**CITY OF MILL CREEK
DESIGN REVIEW BOARD
APPLICATION PL2020-0008**

NAME OF PROJECT: 7Cs Swim School

PROPOSAL: Review of building elevations, streetscape (street trees) and interior landscaping plan.

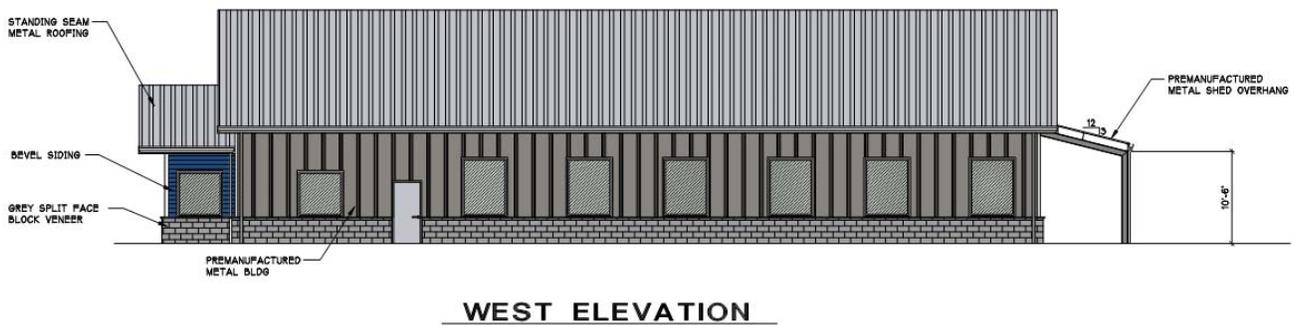
1. The southern and eastern elevations could use additional details to add interest.
2. The applicant has addressed this comment as follows:
 - The eastern elevation has a step-back in the middle which provides modulation. This elevation contains the HVAC systems, which will be screened by a wall constructed of split face CMU, which adds interest. In addition, the locker room, mechanical room, chemical room and pool mechanical room are located along this elevation, which is why no windows are proposed. Please see **Attachment 2 – Floor Plan**.
 - Interest has been added to the southern elevation in several ways including adding trees in the adjacent lawn area, adding the shed overhang between the two roll-up doors, and adding a personnel door.

- The metal roofing material should not contain zinc, which could leach into the wetland buffer. Following the informal review, Mr. Gaskin confirmed that the proposed Galvalume product does contain zinc, so another product would be used. As an alternative to the Galvalume the applicant is proposing a metal roof with a baked enamel finish.

EAST ELEVATION

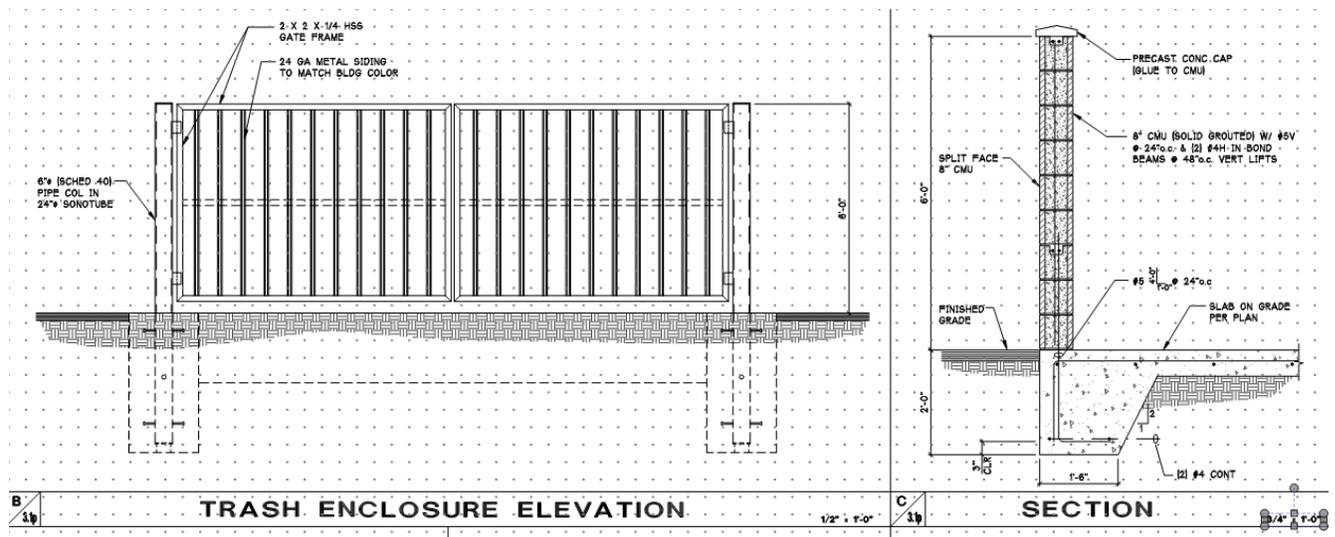
The eastern elevation faces the parking lot and the wetland. The manufactured metal building is Cool Gray Stone with bevel siding on the building entry in Cool Majestic Blue. No windows are proposed on this elevation because of the uses, which include a locker room, and various mechanical and chemical rooms. The HVAC system is screened by a wall gray, split face block veneer. The proposed roof is a metal standing seam roof, enameled in Solar White.

The applicant has proposed a cohesive and subdued color and materials palette, which has been applied consistently around all faces of the building. The exterior consists of a combination of metal siding, board and batten siding, bevel siding and split face block veneer. There are storefront windows on the north and west side of the building. The south side of the building will feature two overhead, roll-up doors and one personnel door, covered by a metal awning, which will lead to a lawn area. The east elevation will have the HVAC systems, which will be screened by split face CMU wall and metal gate. Thus, a consistent visual identity has been applied to all sides of the building, as well as an equivalent level of quality of materials and detailing.
